Interactive comment on “Regional-scale brine migration along vertical pathways due to CO₂ injection – Part 2: a simulated case study in the North German Basin” by Alexander Kissinger et al.

Received and published: 9 March 2017

Interactive comment on *Hydrol. Earth Syst. Sci. Discuss.*, doi:10.5194/hess-2016-687, 2017.

Figure 5.20.: **Left:** Volumetric flow normalized by injection rate into target aquifers through the fault zone. **Right:** Salt flow into target aquifers through fault zone.

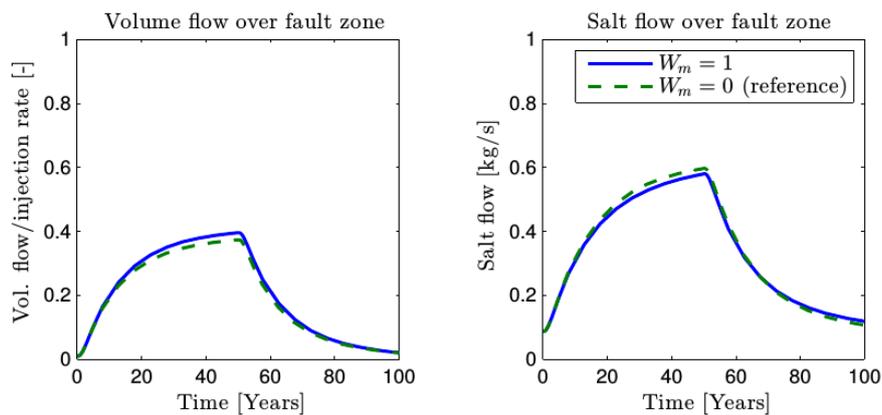
The effects of salt transport: The implementation of the discrete fracture model is such that per default a part of the degree of freedom's (DOF) volume is from the fracture and part from the matrix surrounding the fracture. We have looked at the effect when we neglect the matrix part of the volume at the DOF. This results in a reduced volume at the DOF and therefore a decreased DOF porosity (only fracture volume is active) and an increased transport velocity of the salt water being pushed upwards by the injection. This volume reduction can be as high as a factor of 6 (depending also on fracture and matrix porosities). We have attached a figure describing this comparison from the dissertation Kissinger (2016), see below. Please note that in the figure the "reference" case is not the reference case in this manuscript but the $W_m=1$ case corresponds to the reference case in this manuscript. Here we provide a short summary of the results for more details please consider Kissinger (2016). What we see is that as expected the salt transport into the shallow aquifers increases for the reduced porosity case (only fault zone porosity) compared to the default case (matrix and fracture porosity considered at the DOF). The overall volumetric leakage is also reduced which is a result of the increased weight of the fluid column inside the fault zone which leads to an increased resistance against upward flow. A similar behavior of increasing resistance and lower total mass flow rates due to brine being pushed upward in an improperly sealed abandoned well is reported by Birkholzer (2011). However, the increase in salt transport and the decrease in volumetric leakage we observe for our scenario are rather small.
